ADDENDUM NO. 2

SOUTH SIDE ATHLETIC ANNEX SITE IMPROVEMENTS Fort Wayne Community Schools (FWCS) Fort Wayne, Indiana October 11, 2024

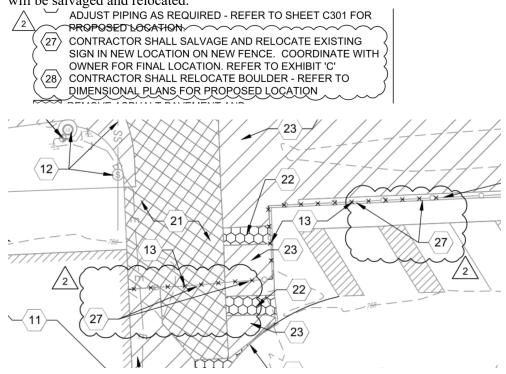
- 1. Plan Sheets C101 and C102
 - A. **REVISED:** Language within keynote #9 to provide clarity on the fence repair needed and to provide reference to Exhibit 'C' within the project manual.
 - 9 CONTRACTOR SHALL REMOVE AND SAFELY DISPOSE OF THE EXISTING PRESS BOX ALONG WITH EXISTING SUPPORTS AND FOUNDATIONS FULL DEPTH. UPON REMOVAL OF PRESS BOX, CONTRACTOR SHALL BE RESPONSIBLE FOR REPAIRING GAP AT TOP OF GRANDSTAND WITH CHAINLINK MESH TO PROVIDE SAFE CONDITIONS, MATCH EXISTING (REFER TO EXHIBIT 'C' IN PROJECT MANUAL)
 - B. **REVISED:** Keynote #14 to provide clarity on scoreboard removal.

REMOVE SCOREBOARD, POSTS AND FOUNDATIONS SAĽVAĞE THĚ "SŠHŠ SOCČER" SĬGŇ OFF SCOREBOARD AND PROVIDE TO OWNER. PROPERLY DISPOSE OF SCOREBOAD, DO NOT RESELL.

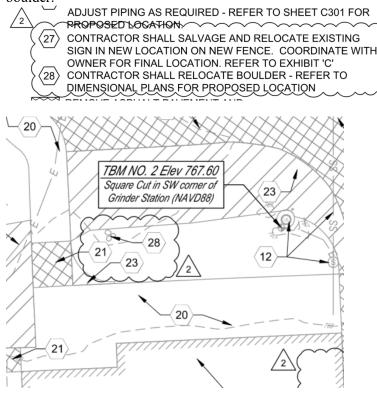
C. **ADDED:** Keynote #27 in legend and on plan to provide clarity on four existing signs that will be salvaged and relocated.

D. **ADDED:** Keynote #28 in legend and on plan regarding the relocation of an existing boulder.

2. Plan Sheet C102

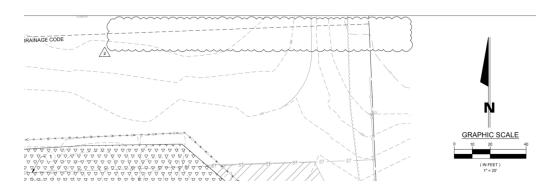
A. **REMOVED:** Note at the top of the page regarding removal of scoreboard north of the track that has already been removed.

3. Plan Sheet C201

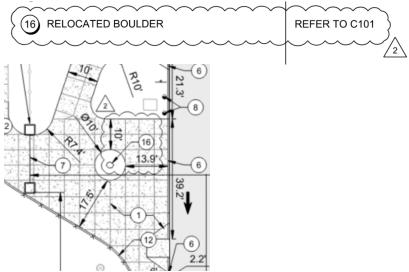
A. **ADDED**: Keynote 16 in legend and on plan regarding the relocation of an existing boulder.
